## DESCRIPTIVE REPORT

*Registry No.* H-11030

*General Locality* Cook Inlet

*Sublocality* Woronzof Shoal to Anchorage

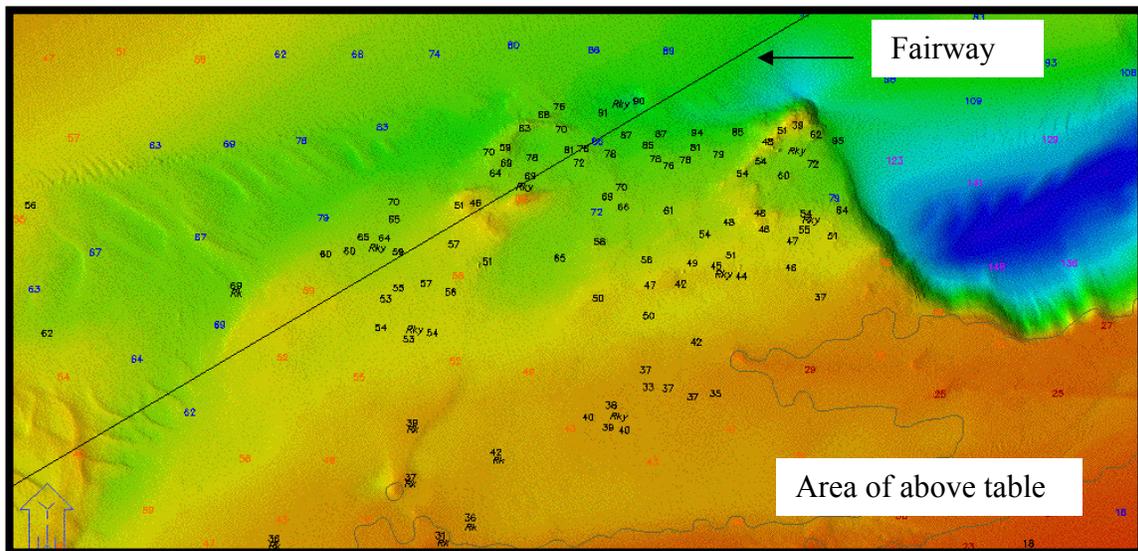
Vicinity	Comment
61°13'15"N and 150°00'39" W	An area of approximately 100 notable rocks. Least depths range from 33 to 95 feet. They surround AWOIS Item 52650. The Fire Island Fairway passes through this rock field. See following screen capture. <sup>23</sup>

- <sup>23</sup> PHB Revision-Selected depths have been noted as “*Rk*” with the surrounding areas noted as “*rky*”.
- <sup>24</sup> PHB Revision-The surrounding area noted as “*rky*”.

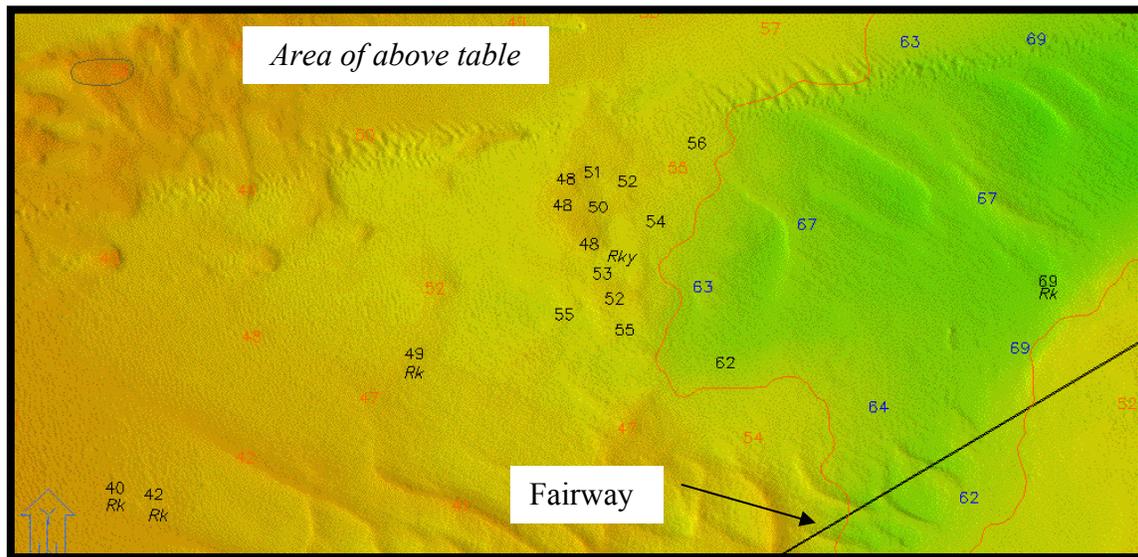
Vicinity	Comment
61°13'07" N and 150°02'35" W	A smaller field is centered approximately at this location with least depths ranging from 48 feet to 62 feet. This area is approximately 580 meters North of the Fire Island Fairway line. See following screen capture. <sup>24</sup>

*Chart 16665 with new survey contours overlaid*

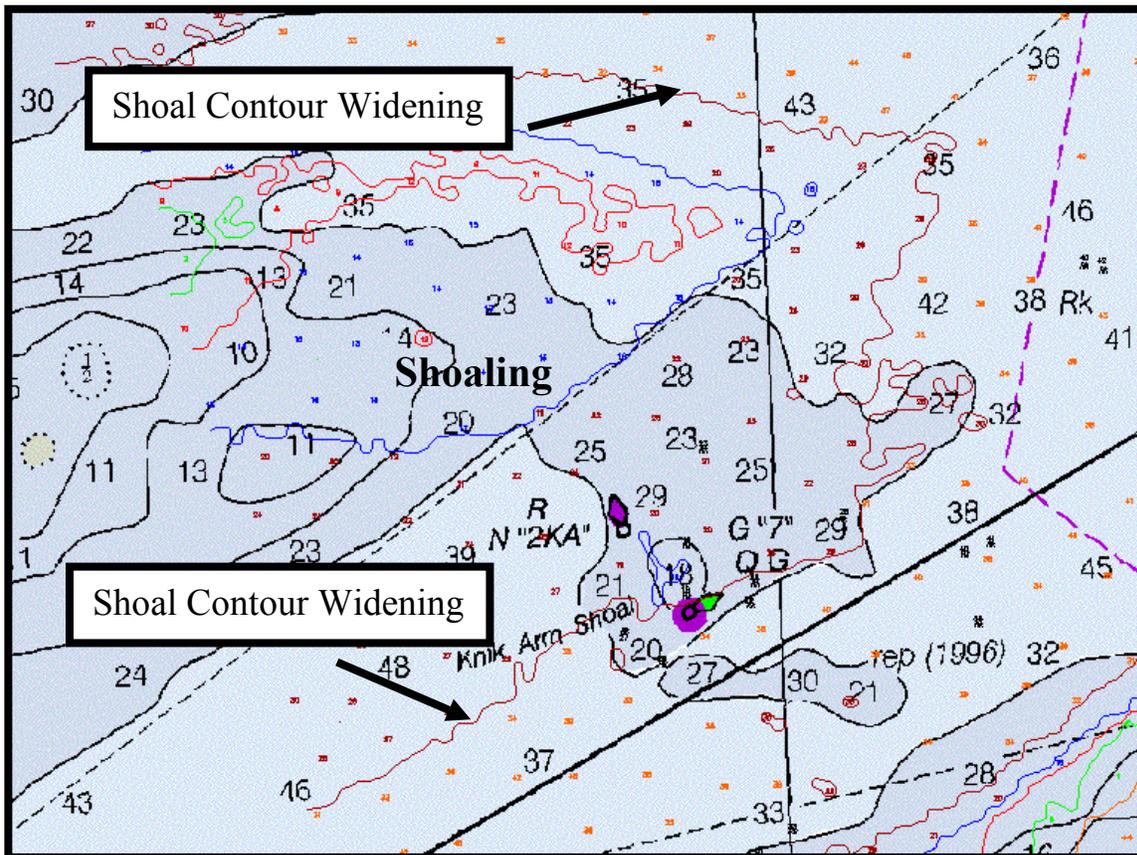
The north end of North Point Shoal lies in the Southerly part of H-11030. The survey encompasses all of Knik Arm Shoal. There is significant widening and increased shoaling of this geographical area. The image below compares the survey to the chart. This is typical of the dynamics of the Cook Inlet bottom and is further described in the Project Wide Data Acquisition and Processing Report and in Section D2 of this report. This area has been addressed in the Danger to Navigation Report, Appendix I.<sup>31</sup>

The newest editions of affected charts should reflect this change. This area will require continuous surveys<sup>32</sup>

- <sup>32</sup> PHP Revision-Do not concur, this area should continue to be included as a resurvey area to the “The National Survey Plan” (2001) and resurveyed at an interval appropriate to local conditions and available resources.

*Chart 16665 with new survey contours overlaid*

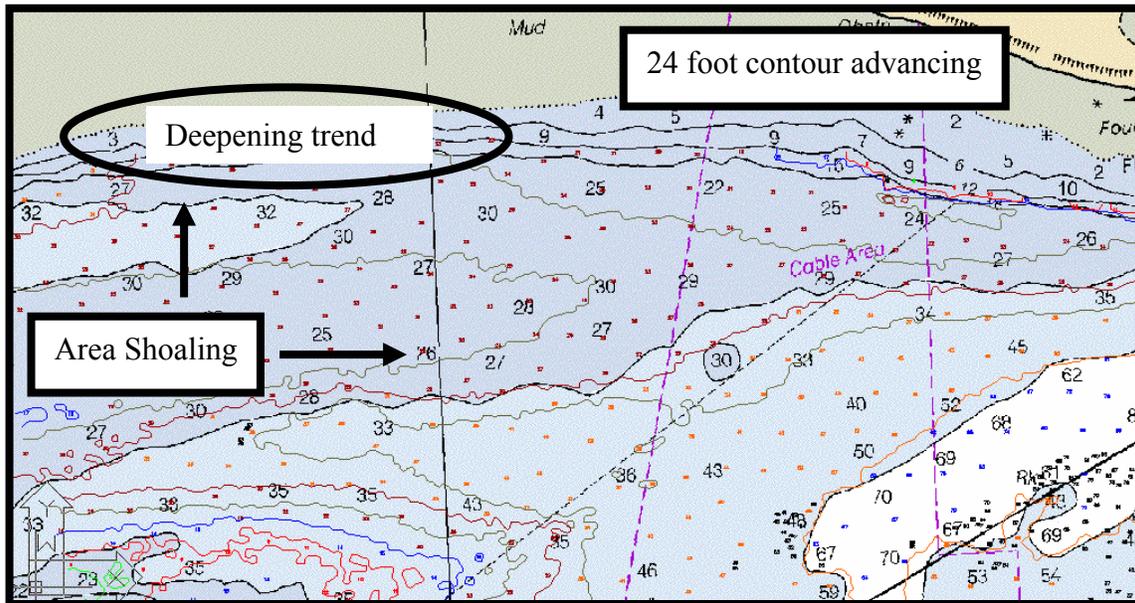
There is a deepening trend on the north side of the survey. The chart shows a channel that slopes up towards the mud, whereas the survey reveals the bottom to be shoaler in the charted channel and then slopes off into new channel where it used to be shoal. Essentially, the channel has migrated North.

The newest editions of affected charts should reflect this change. This area will require continuous surveys.<sup>33</sup>

- <sup>33</sup> PHP Revision-Do not concur, this area should continue to be included as a resurvey area to the “The National Survey Plan” (2001) and resurveyed at an interval appropriate to local conditions and available resources.

*Chart 16665 with new survey contours overlaid*

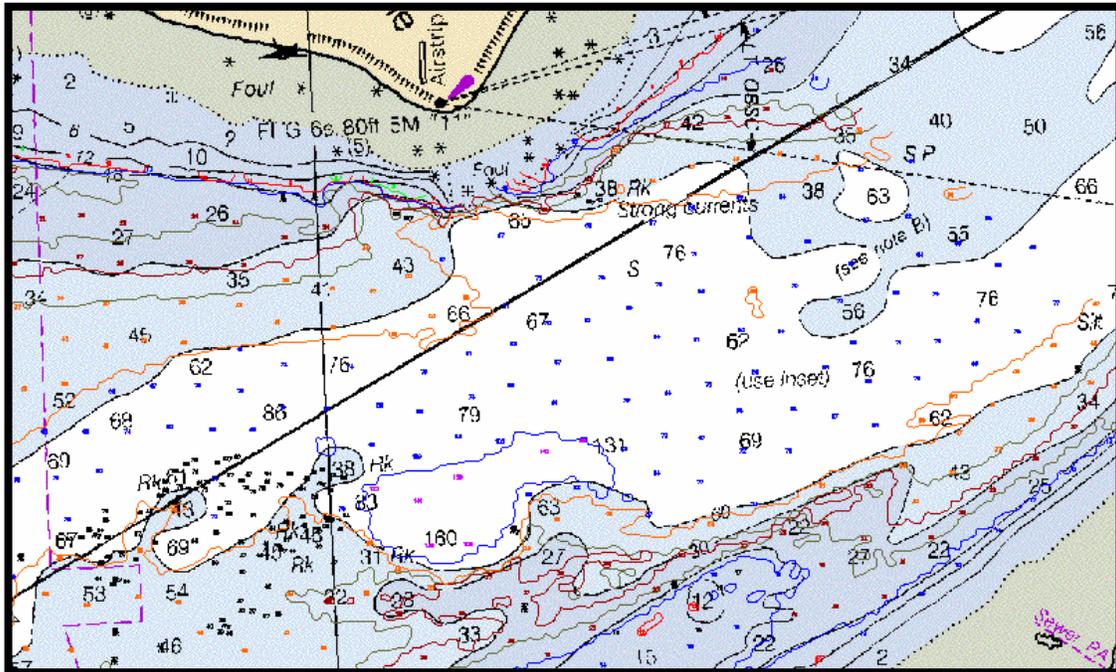
There are both deepening and shoaling trends at the north end of this survey. As noted on the chart, it is an area of strong currents, therefore it is likely in a constant state of flux. This area is critical for mariners needing safe passage to the Port MacKenzie dock.

The newest editions of affected charts should reflect this change. This area will require continuous surveys.<sup>34</sup>

- <sup>34</sup> PHP Revision-Do not concur, this area should continue to be included as a resurvey area to the “The National Survey Plan” (2001) and resurveyed at an interval appropriate to local conditions and available resources.

Chart 16665 with new survey contours overlaid

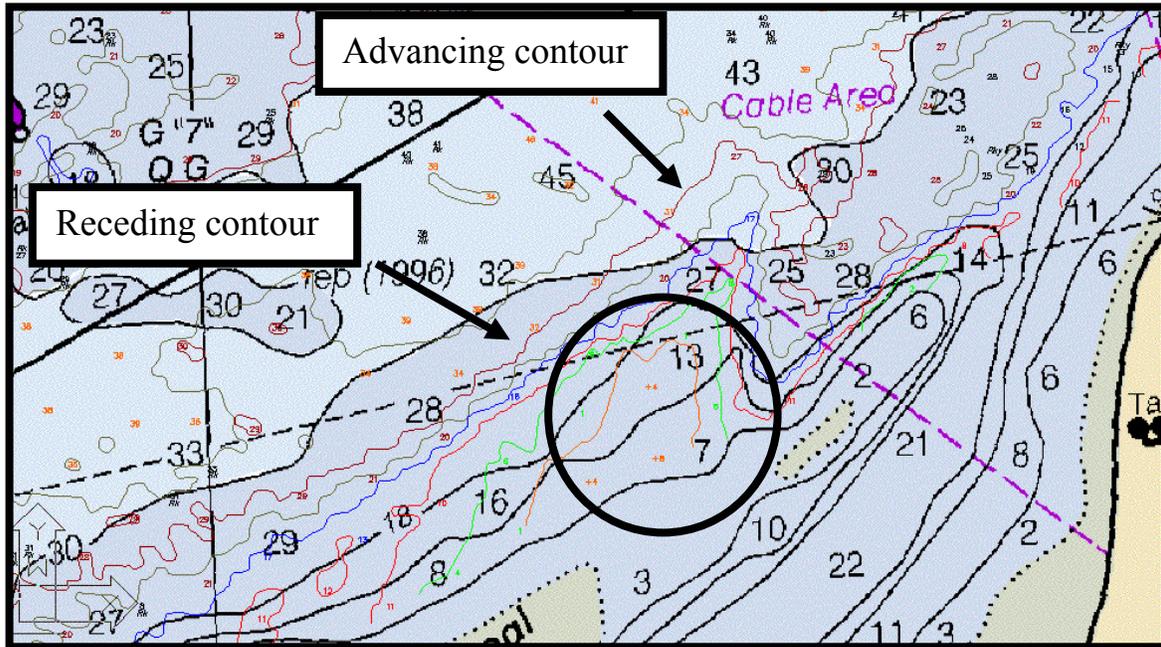
As seen below, the Woronzof Shoal is receding somewhat to the West and advancing to the North. An area just North of the Shoal has silted in above datum. This area has been addressed in the Danger to Navigation Report, Appendix I.<sup>35</sup>

The newest editions of affected charts should reflect this change. This area will require continuous surveys.<sup>36</sup>

<sup>36</sup> PHP Revision-Do not concur, this area should continue to be included as a resurvey area to the “The National Survey Plan” (2001) and resurveyed at an interval appropriate to local conditions and available resources.

*AWOIS Figure 1*

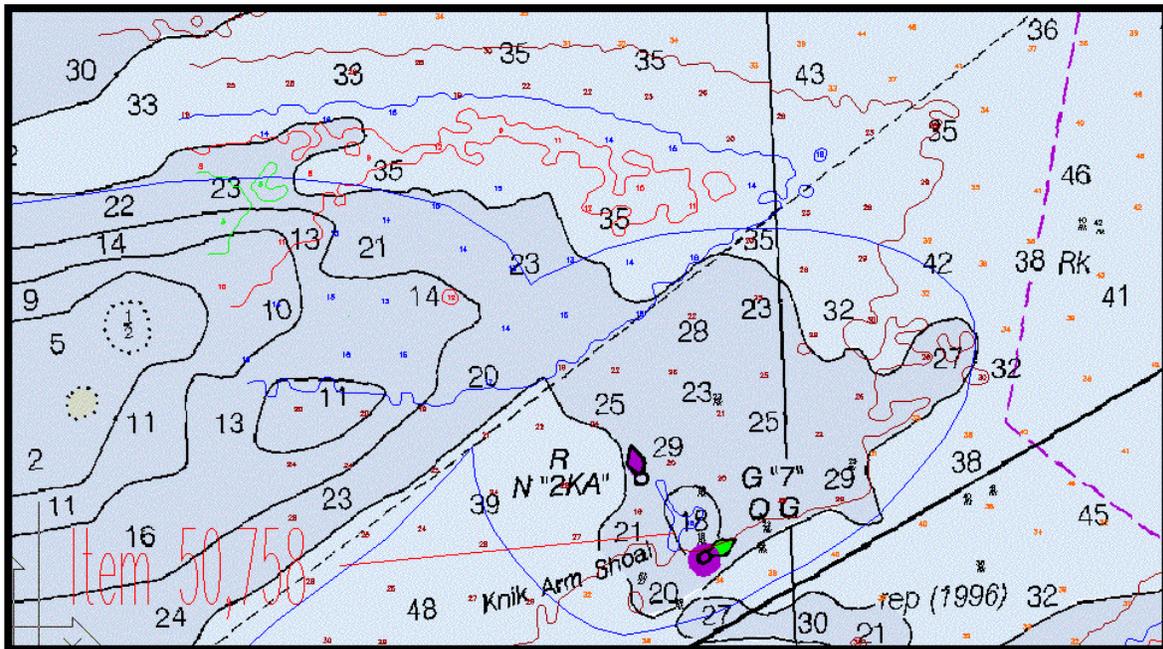
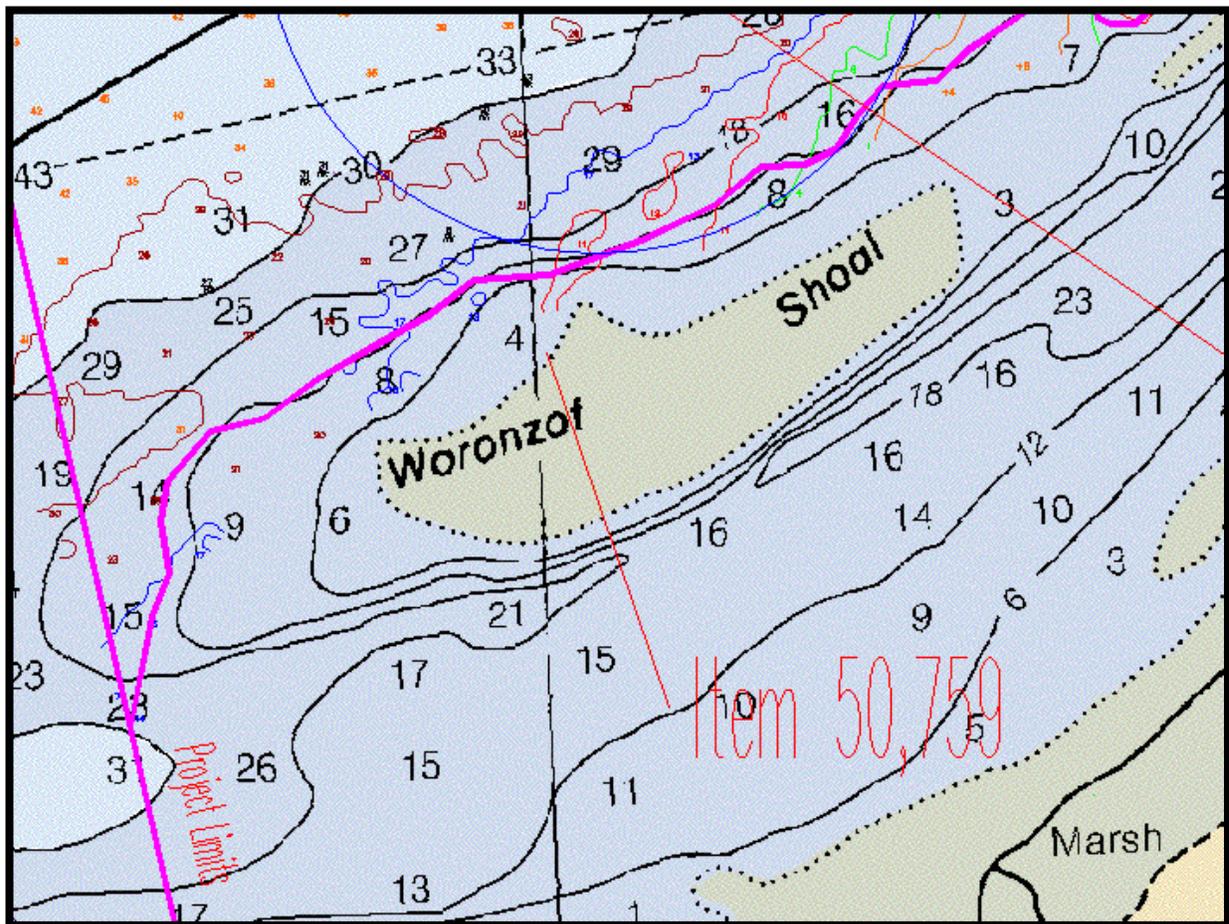
Record	Description	Comment
50758	Knik Arm Shoal	Feature's depth range is 16-29 feet (AWOIS History range is 18-23 feet). Shoal is advancing to the North. See screen capture. See Section D1 of this report for more on shoal definition. See AWOIS Figure 1.

The area has full coverage. The Northeast edge as shown on the chart has migrated Northward. A dredged and maintained channel runs in a North Easterly direction on the South side of Buoy "7". Buoy "2KA" no longer exists. The least depth for the site is 16 feet located just North of Buoy "7".

Remove Buoy "2KA" from the chart. Adjust the contour line to the North to note the migration of the shoal.

<sup>38</sup> PHP Revision- Concur, chart area as shown on smooth sheet.

*AWOIS Figure 4*

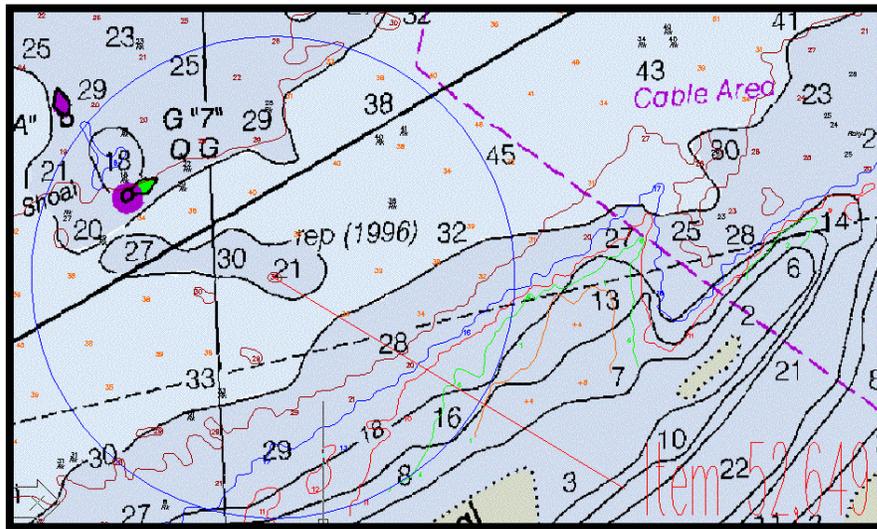
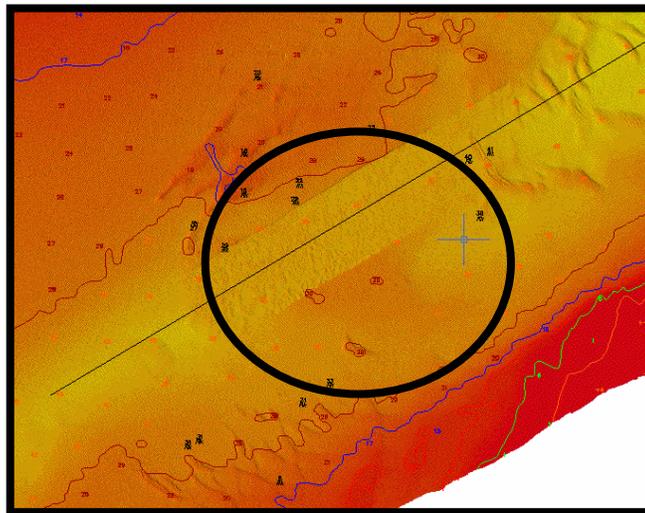
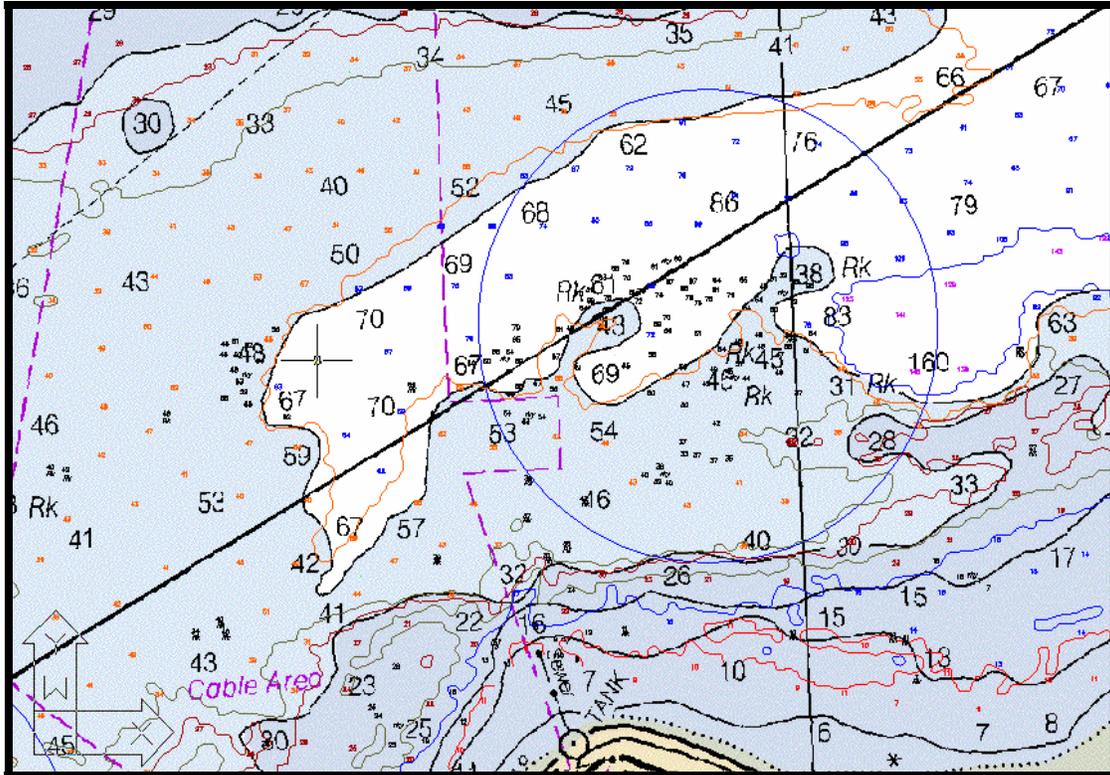
Record	Description	Comment
52649	Shoal	Area still has some depths of 29 to 30 feet. Area is currently a dredged and maintained channel. The shoal is marked on the smoothsheet. See screen capture below. The definition of the shoal is further described in Section D1 of this report. See AWOIS figures 3 and 4.

The area has full coverage. The least depth for the site is 29 feet, and can be found at the South edge of the site. The charted depth for this area is 21 feet. Compared to the chart this area has changed due to dredging and maintenance.

Adjust the contour line to the reduction of the shoal.

<sup>39</sup> PHP Revision- Concur, chart area as shown on smooth sheet.

*Knik Arm Shoal Lighted Buoy 7*

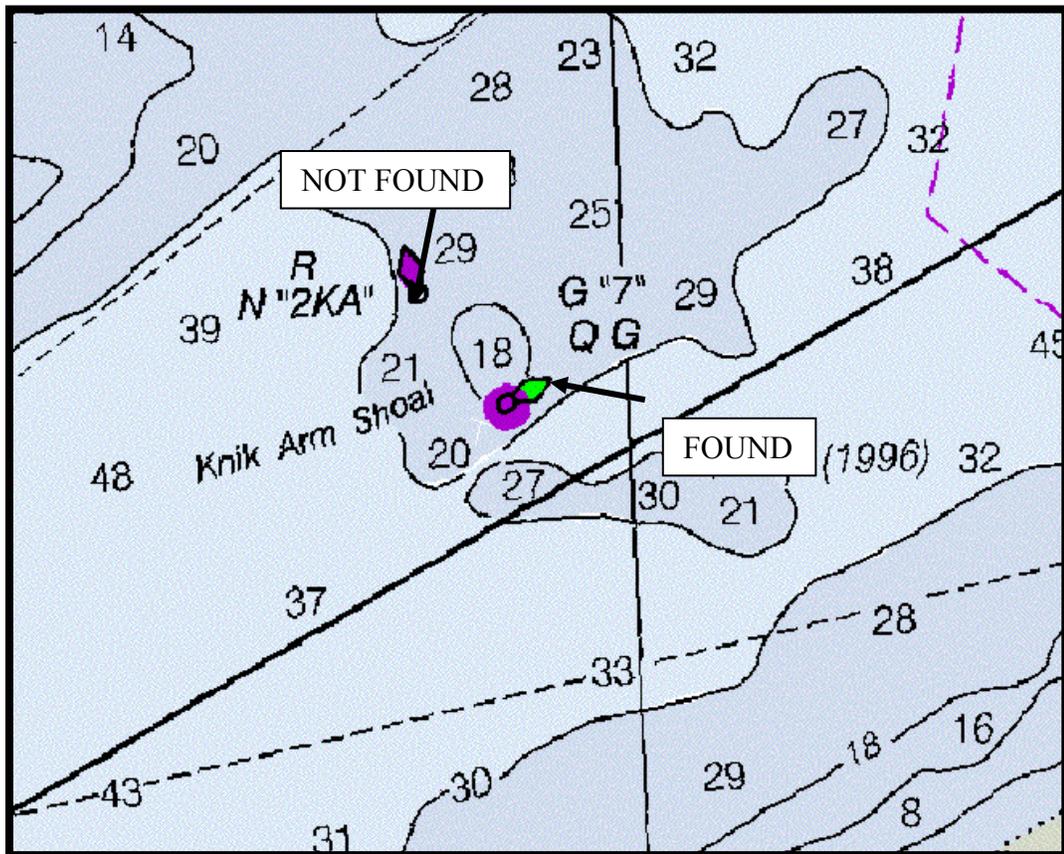
Terra Surveys, LLC hydrographers identified and obtained a position on G"7". It appears to serve it's intended purpose and is at its record position.

Published 2001 Light list Position: 61° 12' 12" N, 150° 05' 24" W<sup>43</sup>

<sup>42</sup> PHP Revision- Continuous Maintenance Drawing, dated 01/22/2003, shows this ATON as *G “5”*. Light List dated 2003, Volume VI list this buoy as “*Knik Arm Shoal Lighted Buoy 5*”, LL No. 26420.

<sup>43</sup> PHP Revision-Surveyed position is Latitude 61/12/12.139N, Longitude 150/05/23.803W

*Enlarged view of the DTM image used to locate cables from this survey, Chart 16665*

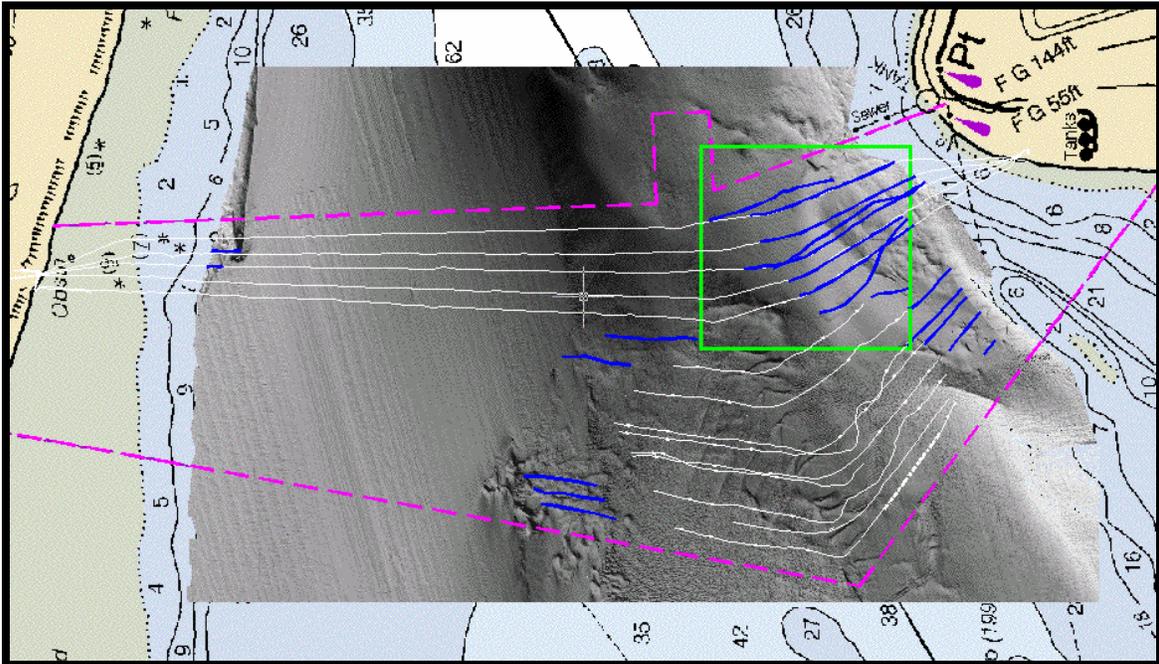
The image below is a plan view of the cable-crossing corridor from Pt. Woronzof to Pt. MacKenzie. Darker lines represent cables detected this survey. Lighter lines are cable locations from prior as-built surveys (supplied by the USACE).<sup>45</sup>

<sup>45</sup> PHP Revision-Retain *cable area* notations as shown on the H-drawing.
